NRC DOCKETS 50-321, 50-366
OPERATING LICENSES DPR-57, NPF-5
EDWIN I. HATCH NUCLEAR PLANT UNITS 1, 2
NRC I&E BULLETIN 80-11

NRC I&E BULLETIN 80-11, "MASONRY WALL DESIGN"

RESPONSE TO NRC REQUEST FOR
ADDITIONAL INFORMATION

EDWIN I. HATCH NUCLEAR PLANT

Project	HATCH - UNIT NO. 1 & 2	Prepared By	TINA C. SALSER	Date	11-21-20
Subject/Title	WALL MODIFICATIONS	Reviewed By	L. W. W. W.	Date	11-21-20
	C-130-39C & 39D (PSOC-20-005)	Calculation Number		Sheet	4 of 7

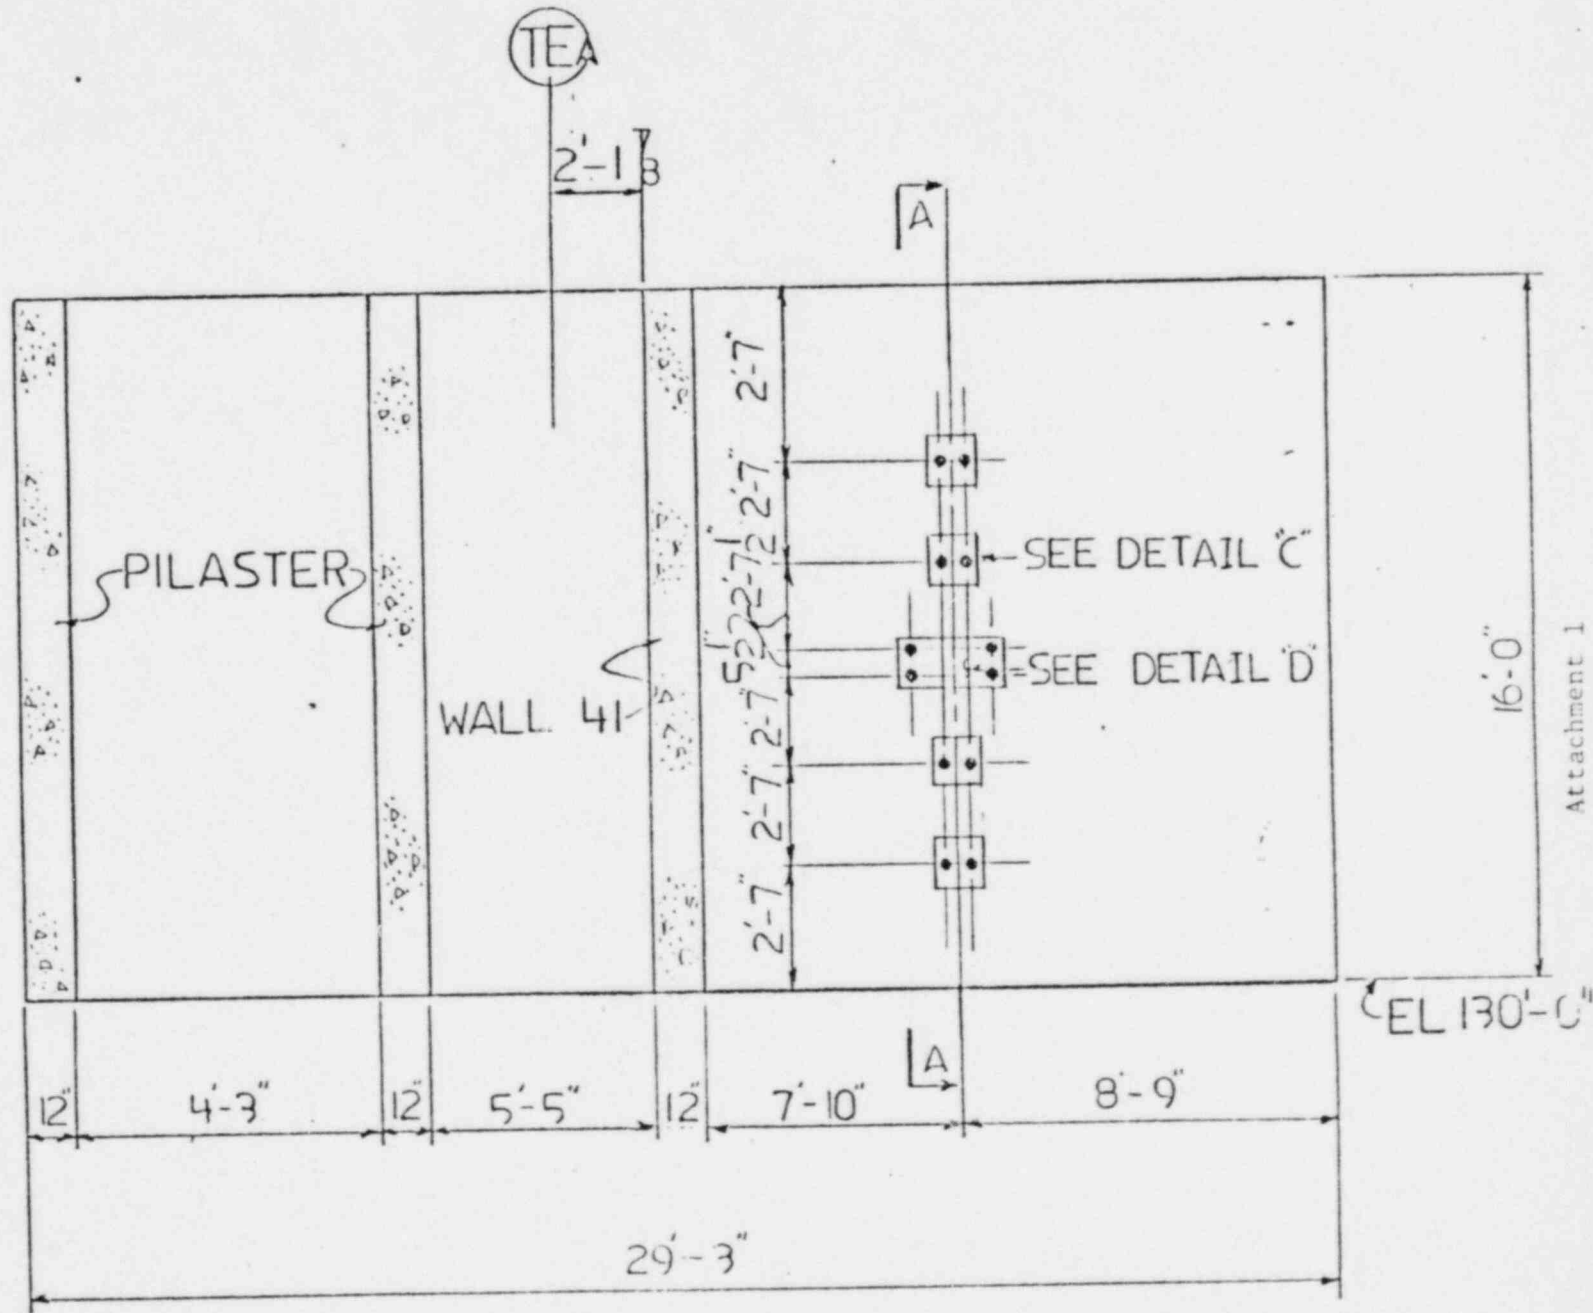
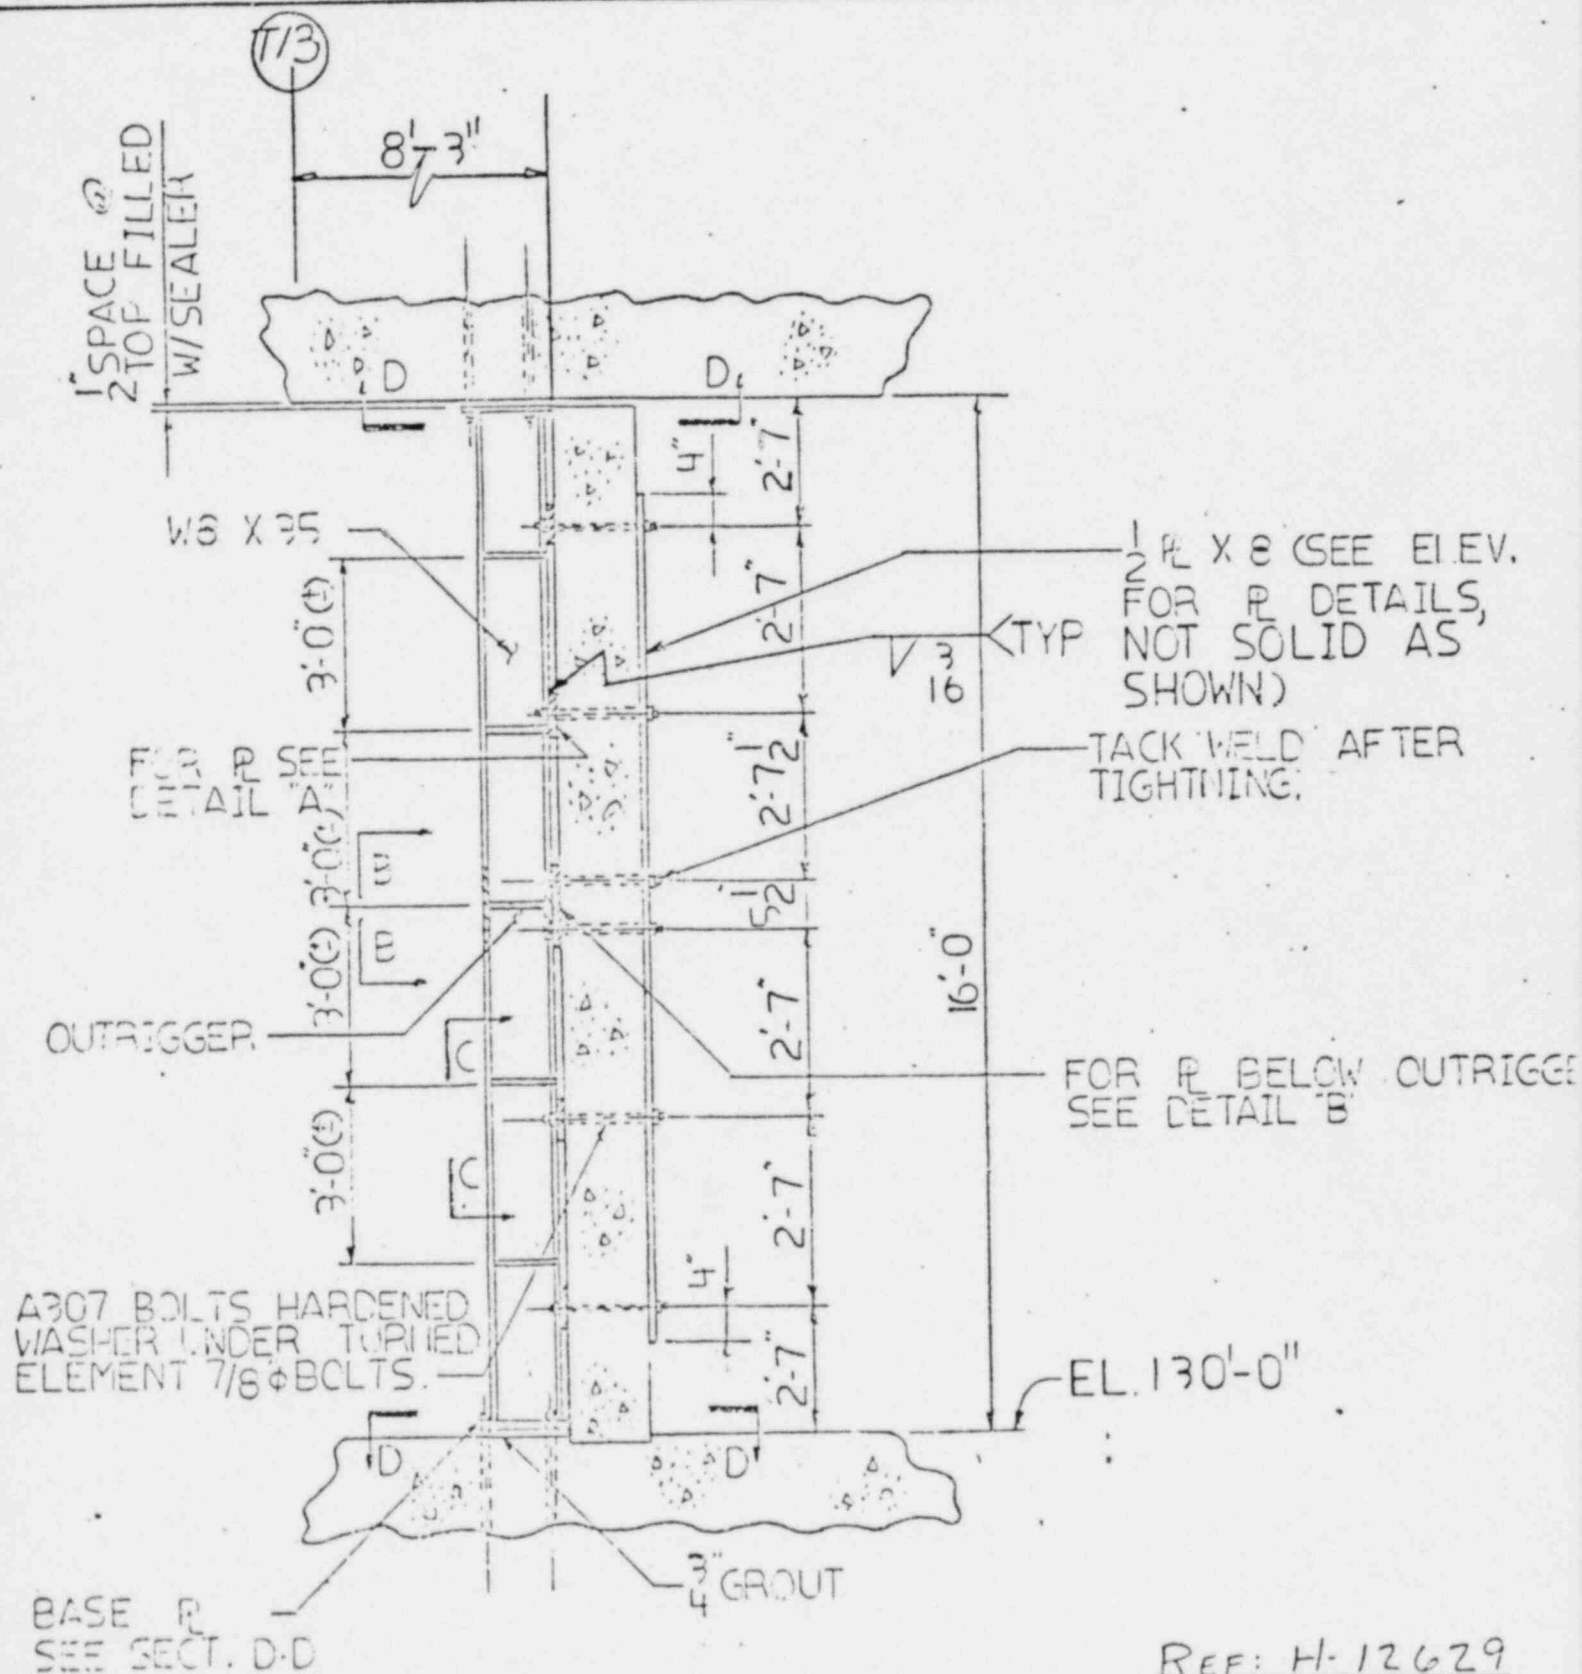
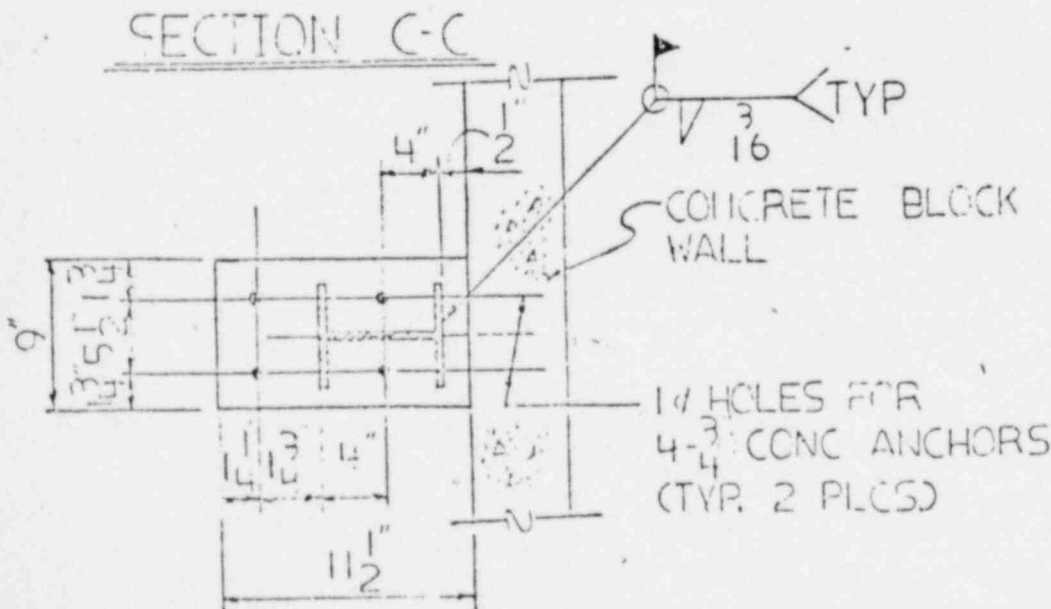
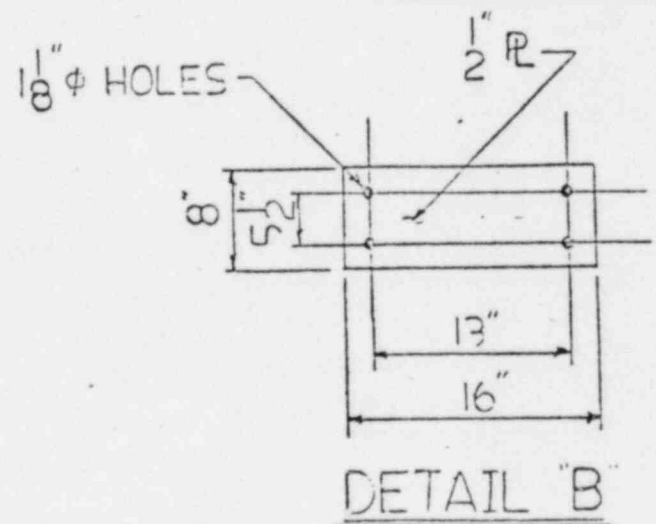
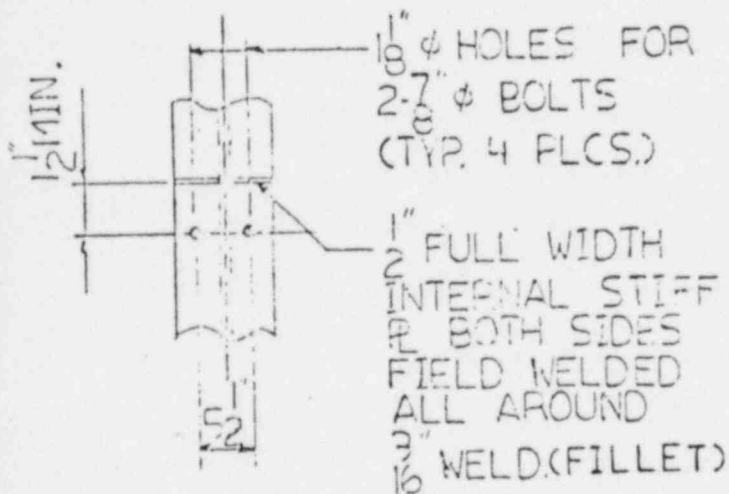
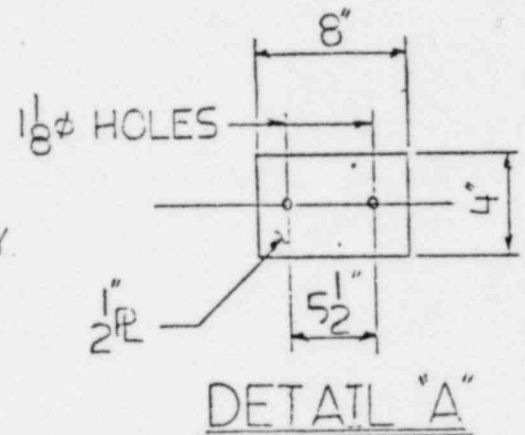
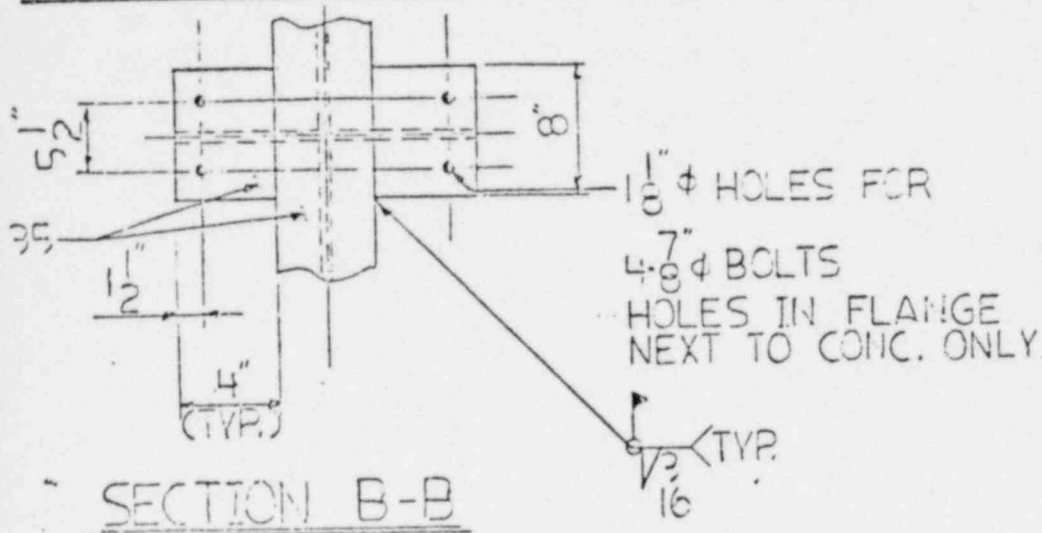
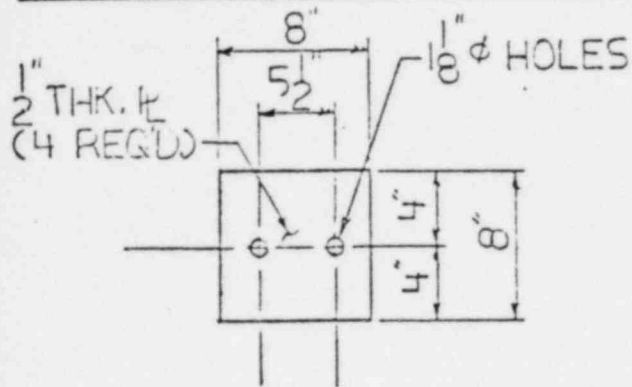
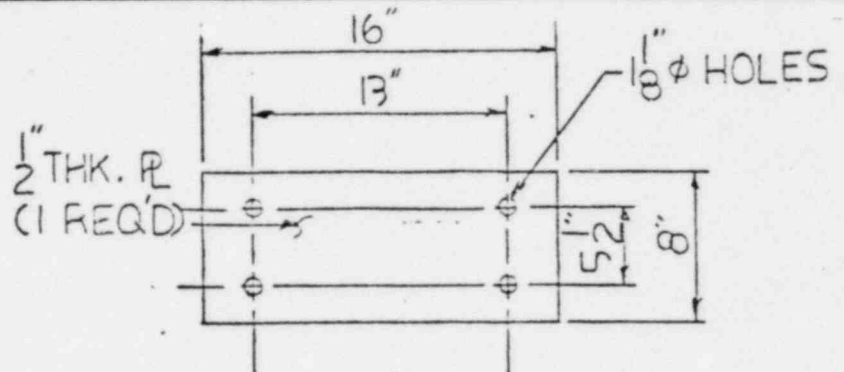
Provide details of modifications for all walls that do not satisfy the design allowables. Technical discussion should be provided detailing how these modifications will correct this deficiency. Also, provide the modification schedule.

A number of walls were modeled for STRUDL-DYNAL and had a finite element analysis run of the as-built condition, taking into account all loads and load combinations. A total of ten (10) walls were identified where calculated stresses exceeded allowable stresses. The results of the analysis showed that the effective horizontal span length of the wall should be reduced. Therefore, a point somewhere within the middle one-third of the span of the wall was chosen considering obstructions and installation problems, and one or more structural steel columns were erected to provide additional support for the wall. The column(s) were designed to withstand the applied loads and were used to brace the wall as shown in the attached sketches. The wall was then re-modeled for STRUDL-DYNAL, including the steel column, and a finite element analysis was performed again for all postulated loads and load combinations. Resulting moments and shears for the masonry wall and support column were checked against allowables. In addition, bolts, plates, and welds for the support having an angle brace were checked for worst-case loads. Wall number C130-14A&B had an angle brace attached to the ceiling on each side of the wall to provide lateral shear support and reduce a local overstress condition to within allowables. Following the analysis using the modified models, each wall was determined to satisfy all stress allowables.

Detailed sketches of the modification for each wall are shown in attachments 1 through 8. The field modifications for each wall are complete except for wall C164-4A&B and wall C130-39A&B. Both of these walls will be removed in the near future to allow for relocation of the shift supervisors office and modifications in the health physics area. Therefore, no modifications have been scheduled for these walls.
